ATTACHMENT 8 - WOLLONGONG DEVELOPMENT CONTROL PLAN 2009 ASSESSMENT

CHAPTER A2 – ECOLOGICALLY SUSTAINABLE DEVELOPMENT

Figure 1: Council's concept public domain design

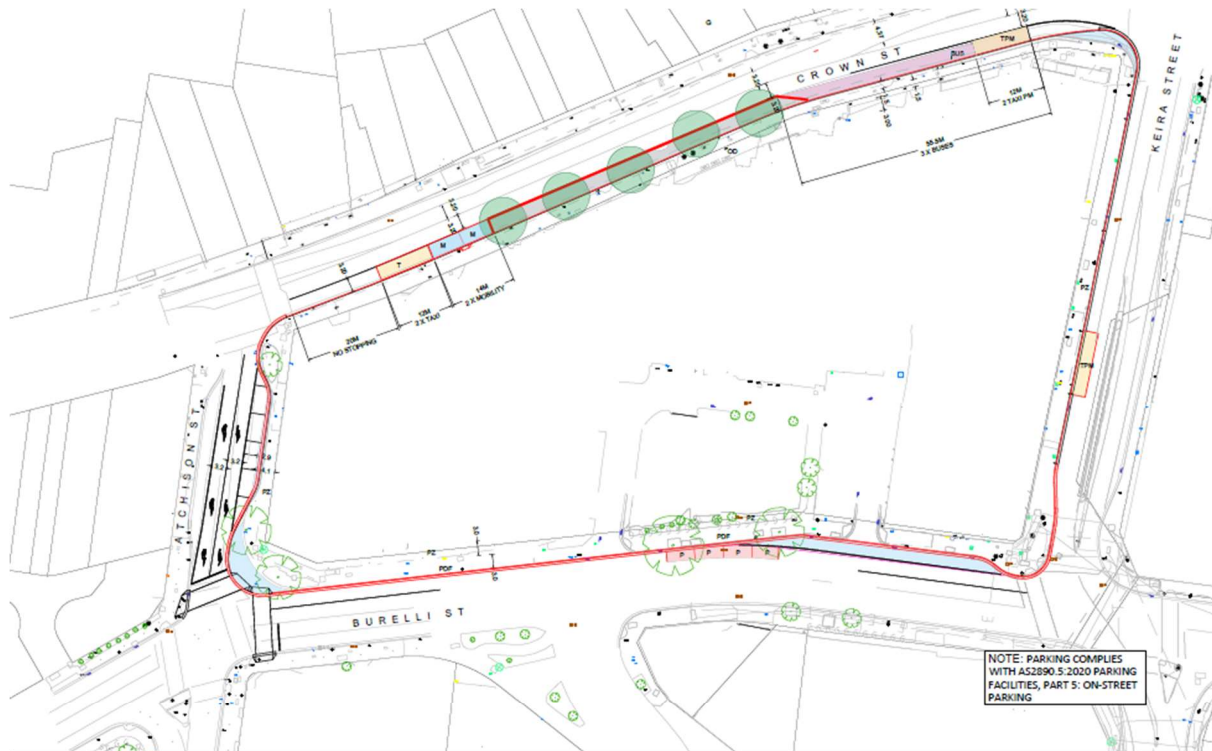
As part of the public domain works, the footpath along the middle section of the Crown Street frontage will be widened, creating a blister in the parking lane to accommodate street tree planting. This option was identified in the pre-lodgement discussions with the applicant, noting in principle support from TfNSW (given Crown Street is an existing classified road).

There are extensive services located within the Crown Street and Burelli Street footpath which presents challenges to street tree planting. Crown Street has been identified as a location at which canopy trees are desirable to address urban greening and improve pedestrian amenity. Trees within blisters in the road have been identified as an alternative to trees in the footpath on Crown Street.

The changes to the footpaths around the site's frontage will improve pedestrian safety and amenity for residents, employees and visitors to the site as well as the broader public. It will also allow adequate space for existing and new street trees, accommodate bus infrastructure and provide improved outdoor dining opportunities for future tenancies on Crown Street.

FIGURE 2 - CONCEPTUAL PERSPECTIVE SHOWING THROUGH SITE LINK STAIR

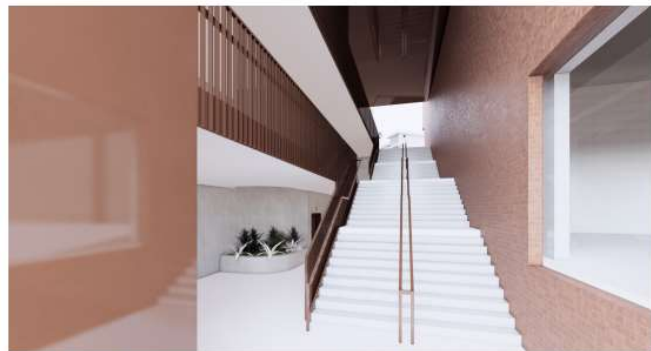
Pedestrian links into the site enable direct sightlines. The Keira Street through link (between the cinema and The Grand) will be conditioned so that lift and lobby access is closed off outside hours of operation to reduce entrapment opportunities. This area is shown below:

Figure 2: Basement Level RL 12.0 showing loading dock and residential and commercial waste storage areas

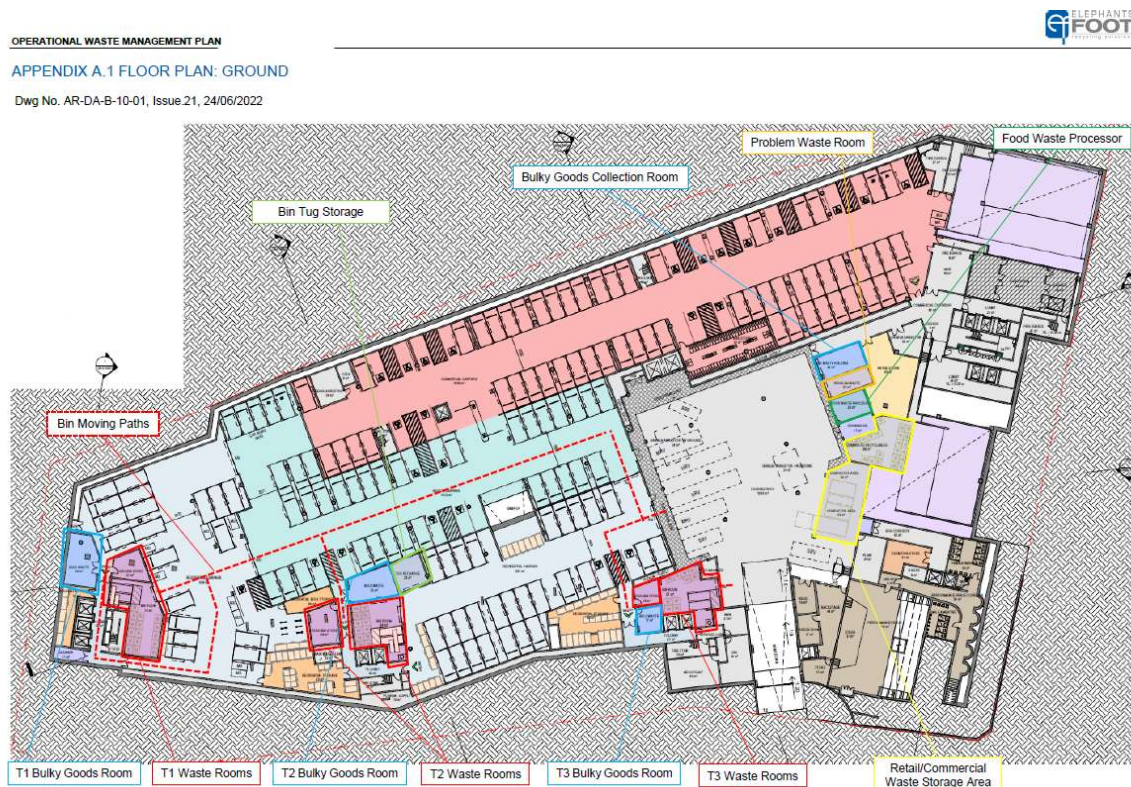
The plan of Basement level RL 12.0 indicating the loading dock and the waste storage areas is shown below:
